MANATEE COUNTY GOVERNMENT

SUBJECT: Invitation for Bid #05-8355-JR
John H. Marble Park Renovation / Construction

ADDENDUM #1

Asphalt RC track

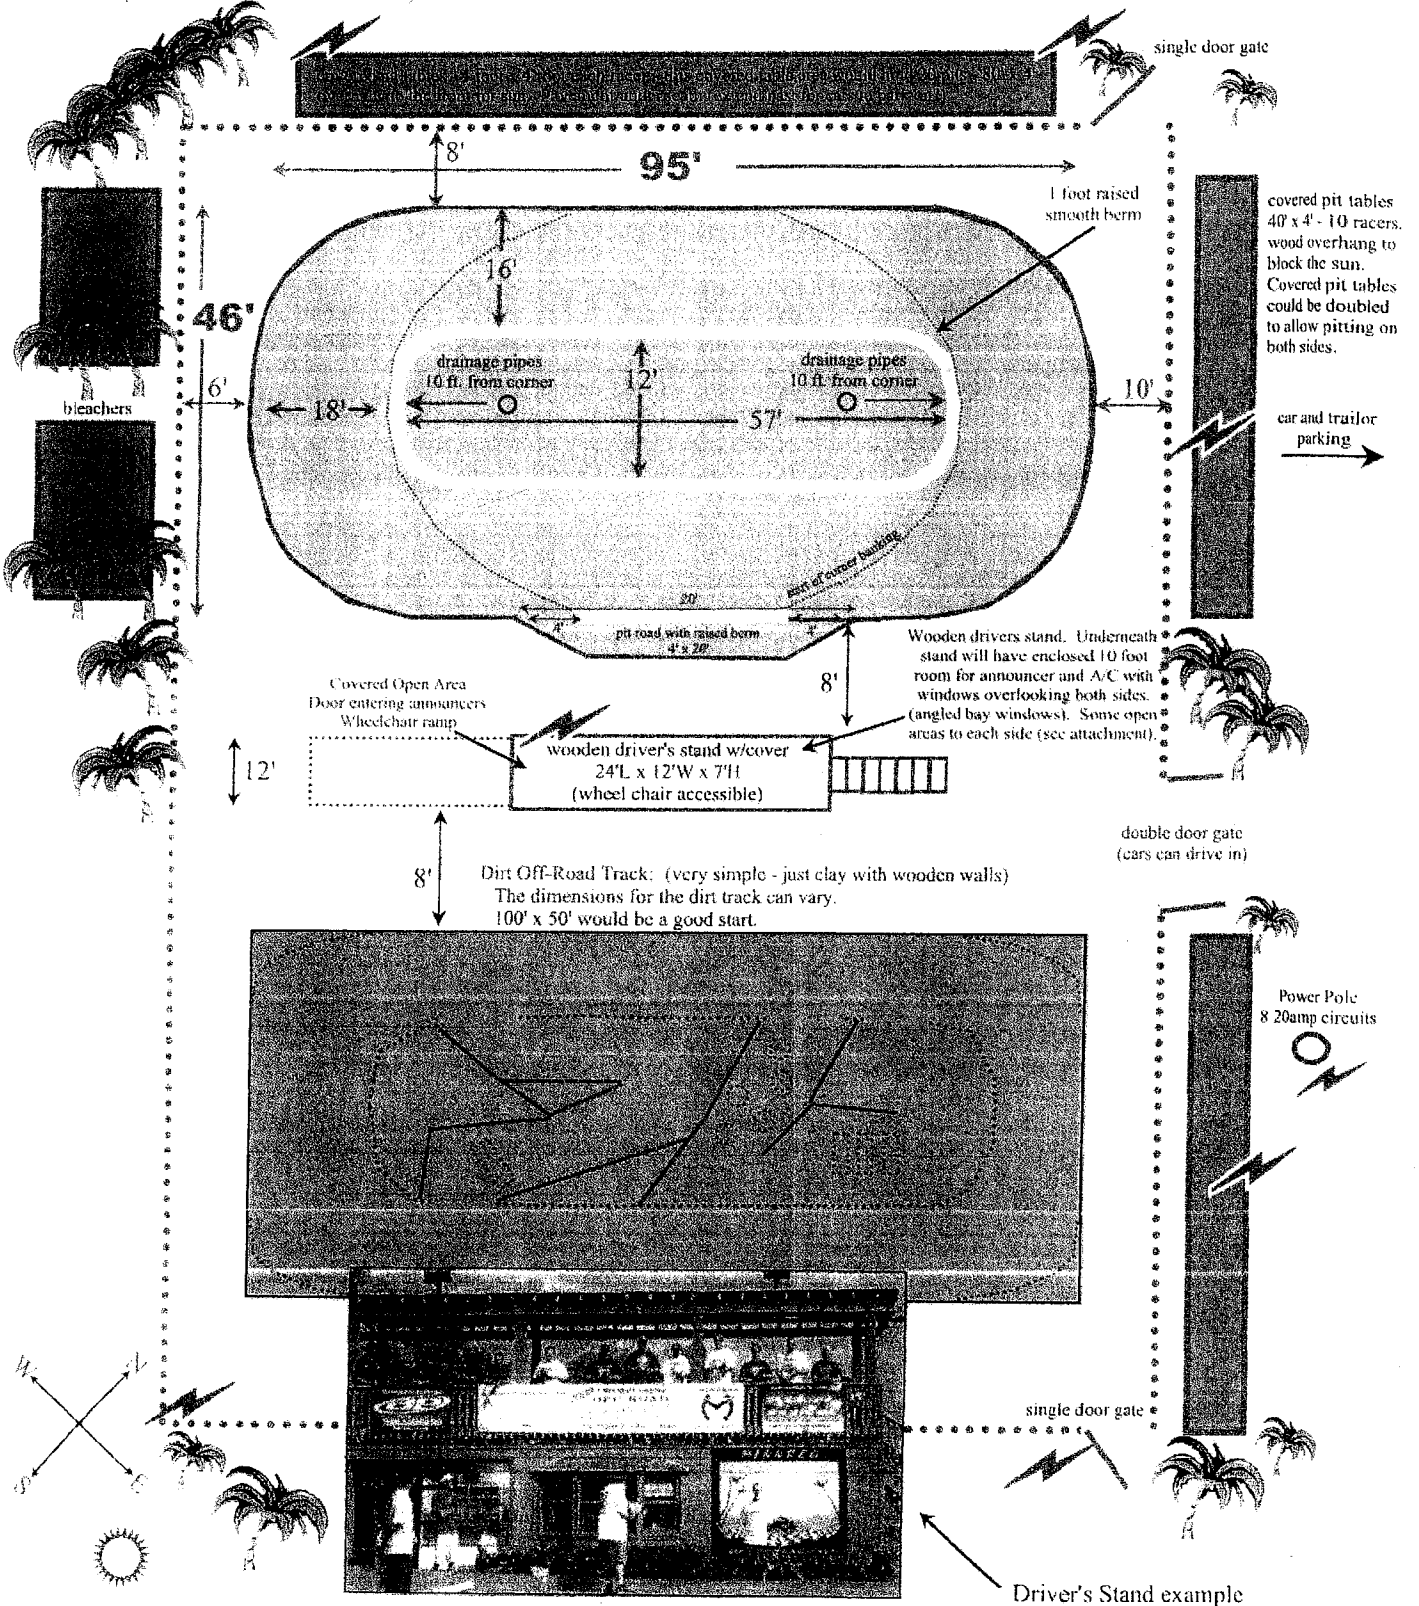
3. Should the curves be banked on the Remote Control Car Track?

4. Does the remote control track require a drain?

The car track should be built according to the attached revised specification drawings. The banking of the curves should be included in the contractor's lump sum price. The guardrails necessary for the car track will be supplied and installed by the County. See attached sketch sheets.

Yes. There will be two drains in the middle of the track, as shown on the sketch sheets provided.

1-2 degrees banking on straightaways with progressive banking in corners with smooth transition going in from straightaways.
 It would be ideal to have about 8-10 degrees of banking on top of corners and almost flat on bottom of corner (1-2 degree to match straight).
 Wooden outside walls with some type of fencing around track area.
 Paved pit row (4 feet wide x 20 feet) with raised berm.
